2020/2471/P - 24 Ferncroft Avenue

Delegated Report (Members Briefing)		Analysis sheet		Expiry Date:	30/07/2020
		N/A / attached		Consultation Expiry Date:	09/08/2020
Officer Obote Hope				Application Number(s) 2020/2471/P	
Application Address 24 Ferncroft Avenue London NW3 7PH				Drawing Numbers Please refer to decision notice	
PO 3/4	Area Team Signature	C&UD	Authorised Officer Signature		
Proposal(s)					
Alteration of the front garden and boundary treatment including the installation of timber automatic vehicle and pedestrian gates, alterations to the existing hardstanding and erection of bin stores.					
Recommendation(s):		Grant conditional planning permission			
Application Type:		Householder Application			
Conditions or Reasons for Refusal:		Refer to Draft Decision Notice			
Informatives:					
Consultations					
Adjoining Occupiers:	No. of responses	00	No. of objections	00	
Summary of consultation responses:	<p>A site notice was displayed from 10/07/2020 which expired 03/08/2020A press notice was published 16/07/2020 which expired 09/08/2020.</p> <p>No responses were received</p>

Householder Application Granted

Alteration of the front garden and boundary treatment includin

Image 4: Proposed elevation (shrubs retained)

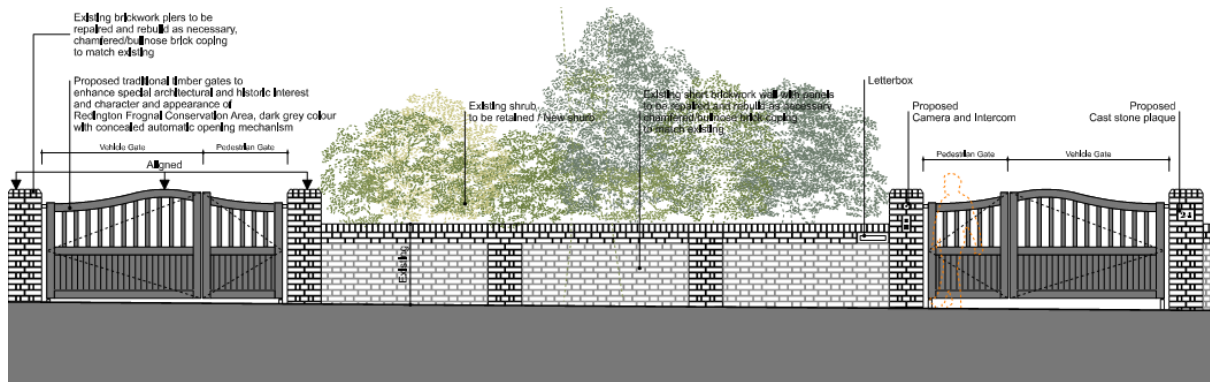
3.3 The proposed metal gates have been omitted from the scheme following officer's comment and officers consider that the proposed timber automatic vehicle / pedestrian inwards opening gates would ensure that the original front boundary treatment for the CHB Quennell houses are maintained.

3.4 Elsewhere along Ferncroft Avenue, low red brick walls with varying amounts of green vegetation is the established boundary treatment, usually with open rather than gated driveways. However, several nearby properties have installed gates including a few isolated instances of metal fences / gates. The proposed timber gates are considered to be a sensitive approach to providing a gate to the existing forecourt and would not significantly alter or detract from the character and appearance of the host building or the wider Redington/Frognaal Conservation Area

1.2 The initial scheme has been revised and the metal electronic gates have been omitted and replaced with timber gates.
